RESPONSE TO RANDWICK DESIGN EXCELLENCE PANEL RECOMMENDATIONS REPORT DATED JULY 2020 DA/249/2020

PROPOSAL AT CHAMPAGNAT CATHOLIC COLLEGE – PROPOSED REPLACEMENT BUILDING (BLOCK B)

ON BEHALF OF
Sydney Catholic Schools

03/SEPTEMBER/2020
1912-W1-05

Figure 3 Drawing DA2956

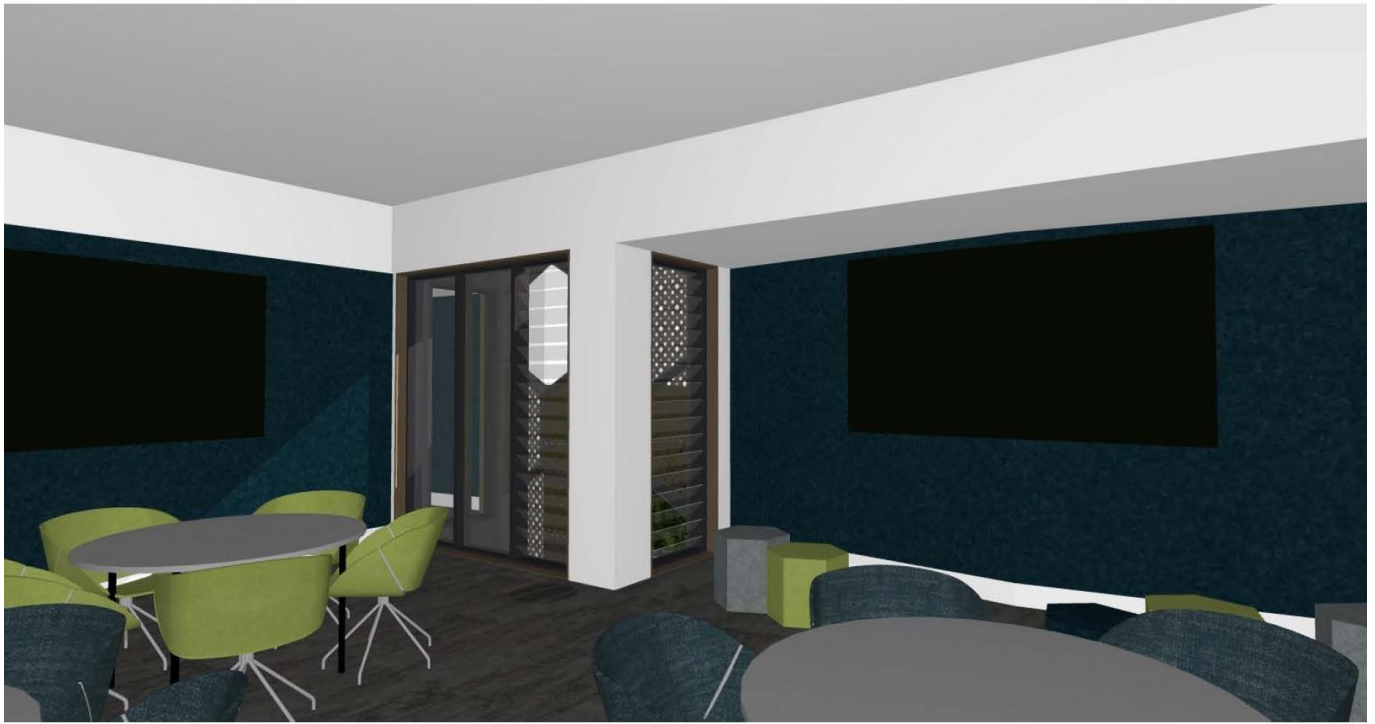
Functioning of seminar rooms

The seminar spaces are embedded in the GLAs with a third wall opening onto the learning common so that they are directly accessible to all of these spaces. Direct access and visibility to the adjacent GLA is required for supervision. Refer figure 3 describing the 3D view of the GLA and Seminar space.

Response: The design of the building and particularly the configuration of the GLAs, learning commons and seminar spaces is the result of approximately 1000 hours of consultation between Architect, Sydney Catholic Schools and school staff. The design has progressed through a 3 tier review process and as a result the client has made an informed decision to accept this design.

Figure 5 Drawing DA2955

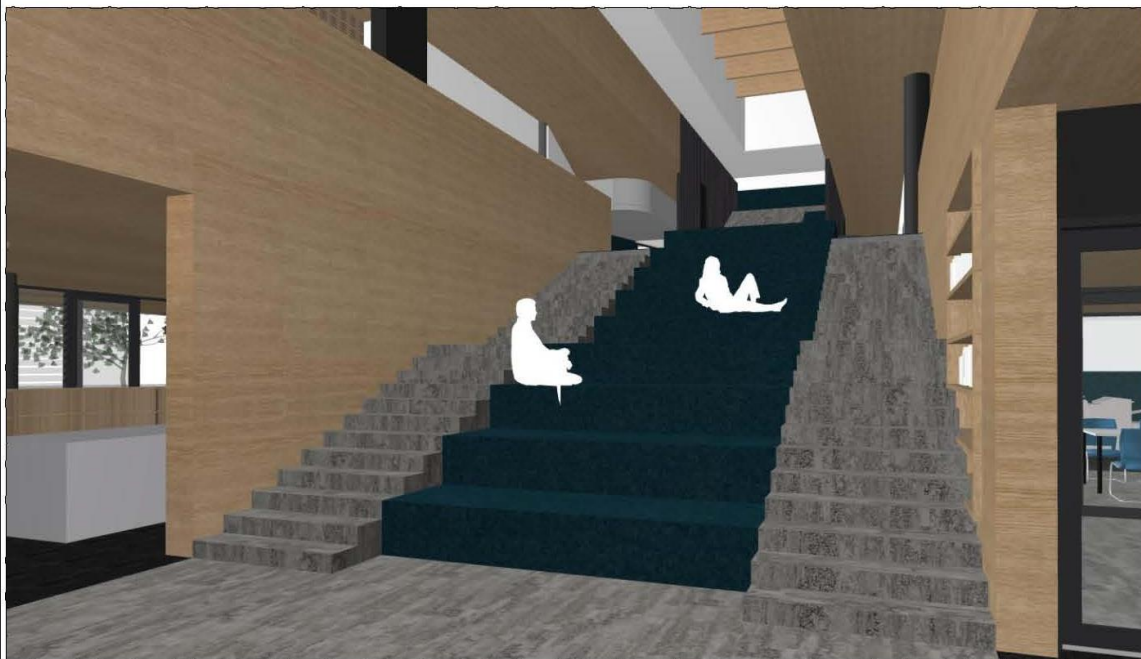
Stair drawing is confusing:

Stair B1 circulation:

Response: Figure 5 shows 3D view of all stairs for clarity.

Response: Stair B1 is a required exit under the National Construction Code. Principal circulation stairs are stair B2 and the stairs within the tiered learning areas. These stairs provide ample provision for circulation within the building interior.

Figure 7 Drawing DA2300

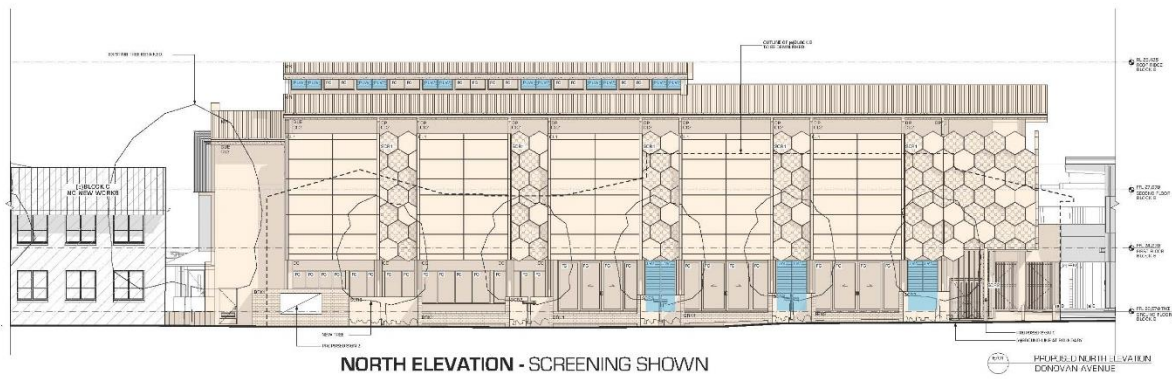
Cross section through voids:

Response: An east-west cross section through the stair voids is provided in figure 6. Figure 6 describes the passive ventilation effect of the thermal chimney when in operation.

Figure 11 Drawing DA2220
Shading of Ground floor provided by First floor

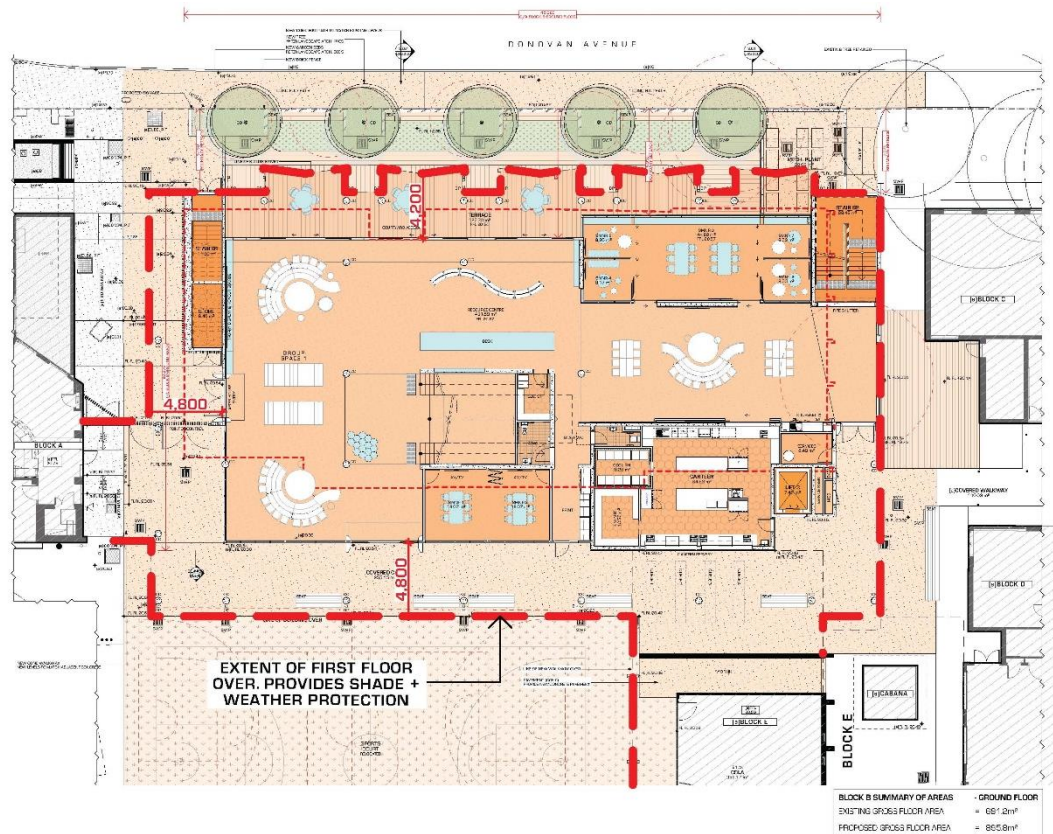
Sun shading and weather protection:

Response: Figure 11, 12, 13 describe sun shading and weather protection proposed. The building is adequately shaded and weather protected.

Figure 14 Drawing DA2220

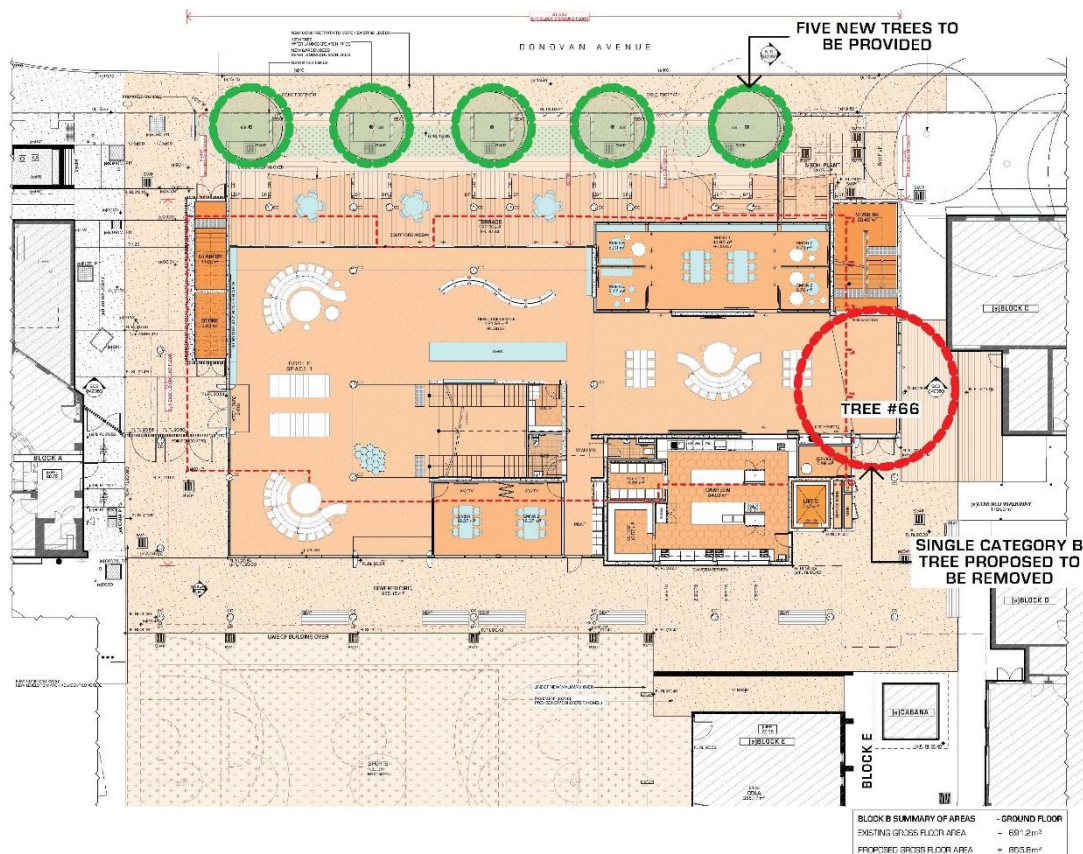
Landscape:

Response: Nine existing trees are proposed to be removed. Only one of these is a category B ranked tree (refer figure 14). The remainder are category C trees. The arborist report submitted with the DA identifies Category C trees as low retention value.

Five new trees are proposed. The new trees more than compensate for the removal of the single category B tree.

RUBBISH REMOVAL AND CANTEEN SERVICING
Figure 15 Drawing DA1100

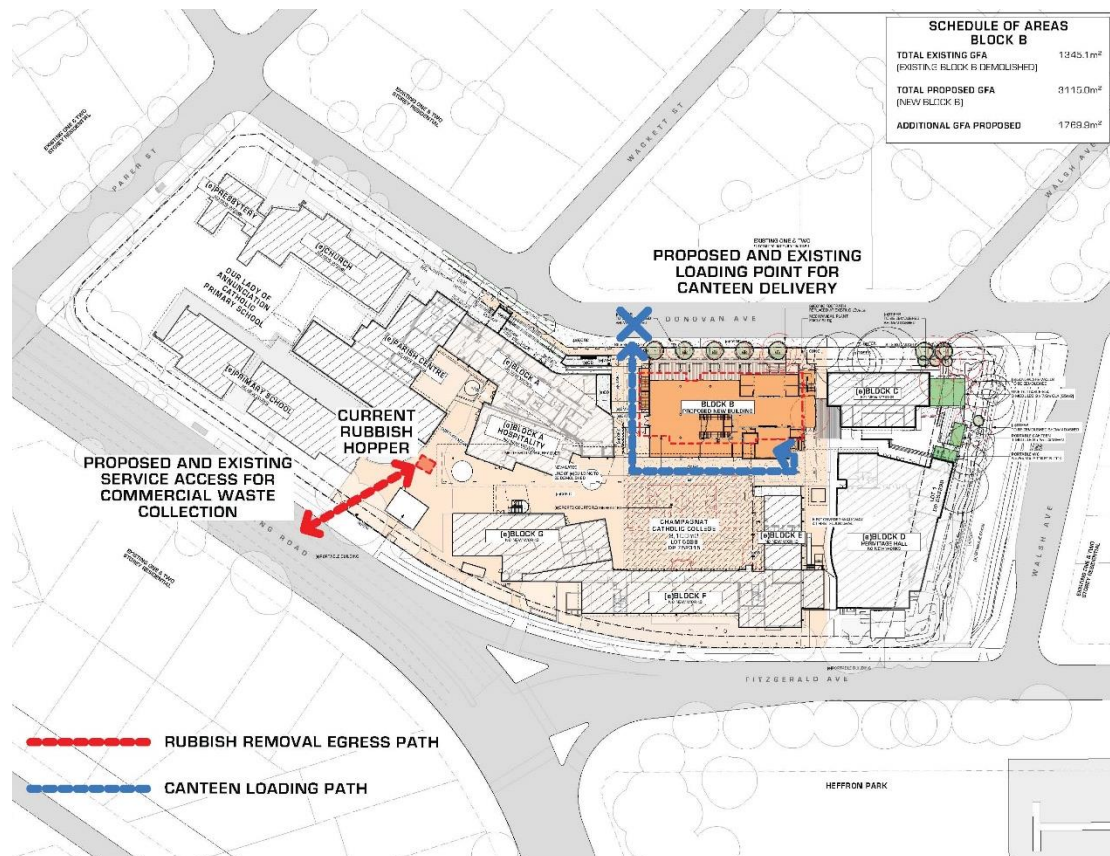
Amenity:

Existing rubbish removal and canteen deliveries are unaltered by this proposal. Figure 15 describes location of current rubbish collection and canteen delivery.

Figure 17 Drawing DA2257

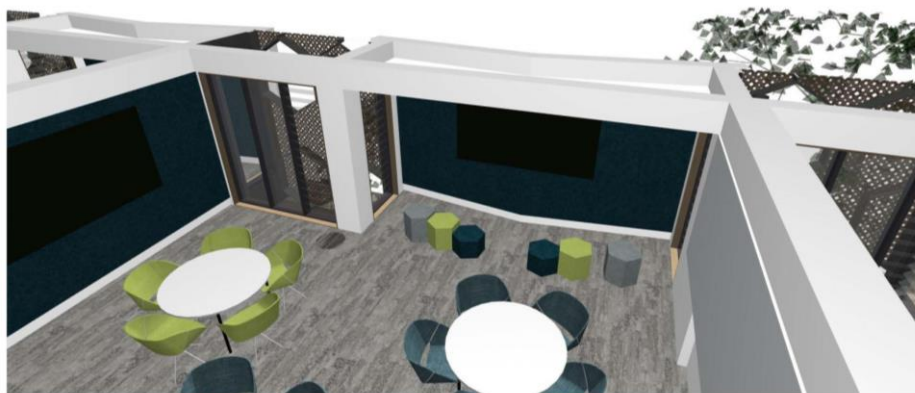
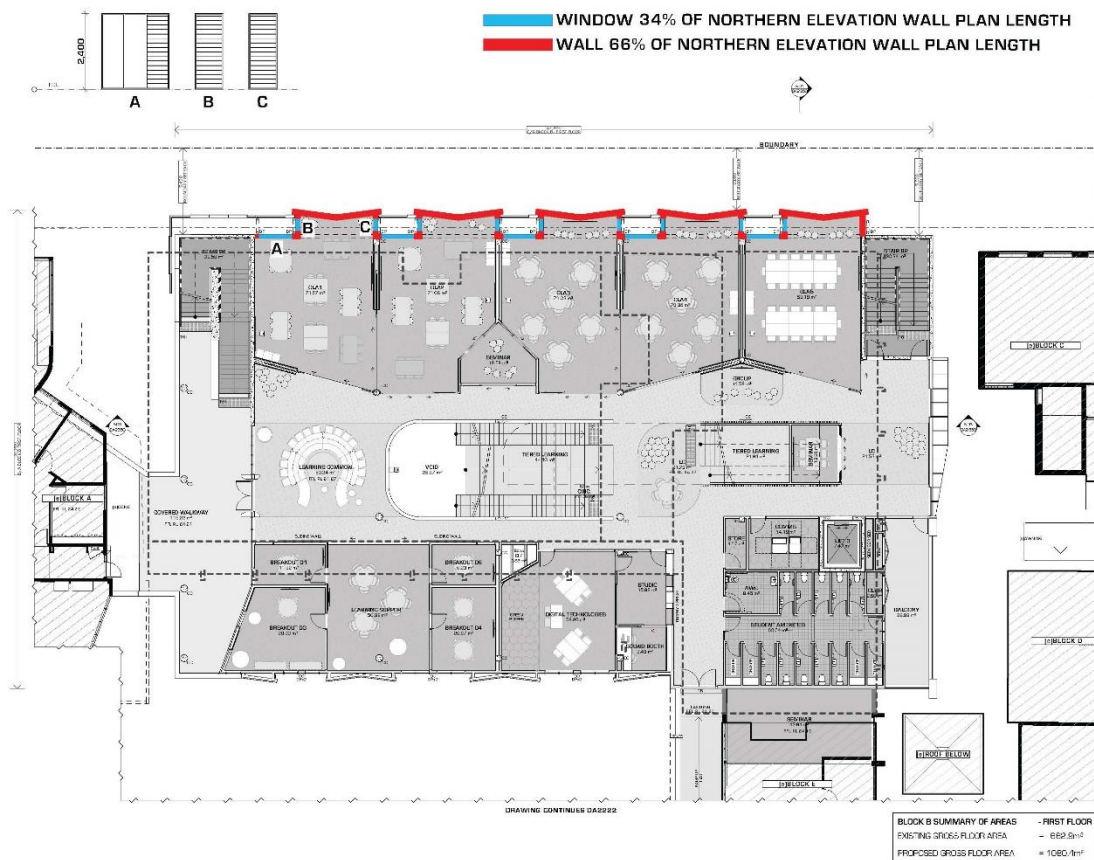
Aesthetics:

The north elevation of each class room is provided with windows along 34% of its plan length. Figure 16 describes the plan extent of windows located on the northern elevation. These windows are 2100mm high and 70% opening. Figure 17 describes a view of the extent of glazing to the north wall of a typical classroom on first and second floors.

Further, the sections of solid wall proposed on the northern elevation are a functional response to the use of the adjacent internal spaces. Refer to figure 17. The design response has been to integrate the function requirement of the façade with an appropriately scaled and integrated series of façade elements.
